PRODUCT BULLETIN

Date: Oct 07, 2019
Update Number: P2019-26
Subject: CAPXL Updated Firmware Release v1.28
Product Affected: CAPXL

Type of Change: 1.28 Firmware Release for CAPXL

Figure 1: update firmware button screen shot from Controllers screen

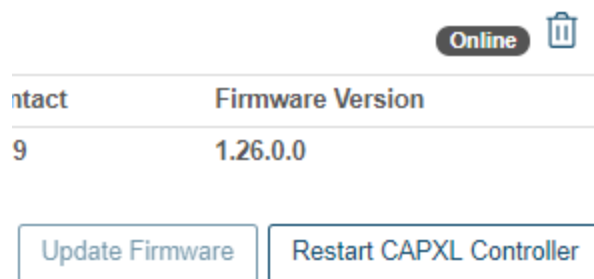
4. Click the "Update Firmware" button.
 - a. **Press the button only once.** Repressing the upgrade button may restart the process resulting in longer upgrade times
 - b. A confirmation message will appear and the CAPXL will immediately begin downloading the new firmware and will automatically perform a restart. After the restart, the CAPXL will maintain its previous settings and resident database. After the restart is complete, it will show as Online and the Update Firmware button will no longer be active.
